## SE Cooling Fan Monitoring Switch Kit (SE40FAN) Notification and Recommendations For SED364000 Circuit Breakers

#### POTENTIAL PRODUCT NON CONFORMANCE

**Figure 1: Date Code Locations on SE 4000 A Circuit Breakers**

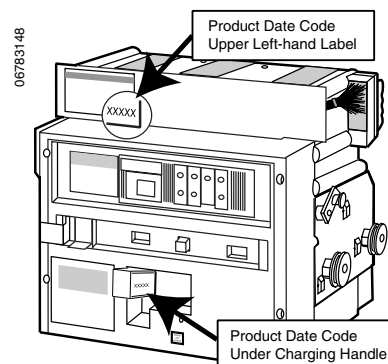
1. The breaker must be a 4000 A model, drawout construction, and within the **date code range from 98011 to 05515** (Manufactured from January 1st, 1998 through December 25, 2005). The date code can be found on the product as indicated in Figure 1.
2. The temperature and current load must be high enough to cause the cooling fans to cycle. Typically this is above 3200 A but to be safe any breaker operating above 3000 A should be considered.

**Figure 4: Recommended Wiring**

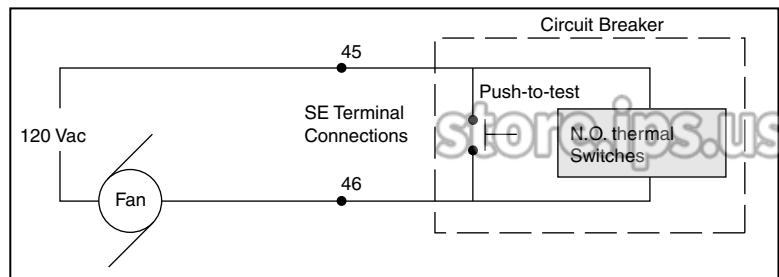
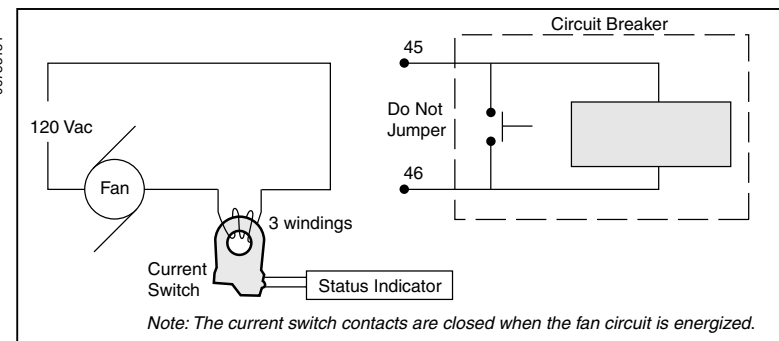
The cause of the metering error is related to a circuit element in the trip system that is inadvertently triggered by system noise generated in the fan cooling circuit.

The modification shunts the fan currents around the circuit breaker control wiring harness for continuous fan operation. This modification also provides a means for indicating the status of the fan circuit.

1. Disconnect the fan circuit from terminals 45 and 46 of circuit breaker.  
*NOTE: Do not jumper terminals 45 and 46.*
2. Install current switch (supplied) into the cooling fan circuit as shown in Figure 4. The cooling fan should be energized for continuous operation.
3. Install a fan circuit status indicator to the current switch contacts.  
*NOTE: The current switch contacts are closed when the fan circuit is energized.*
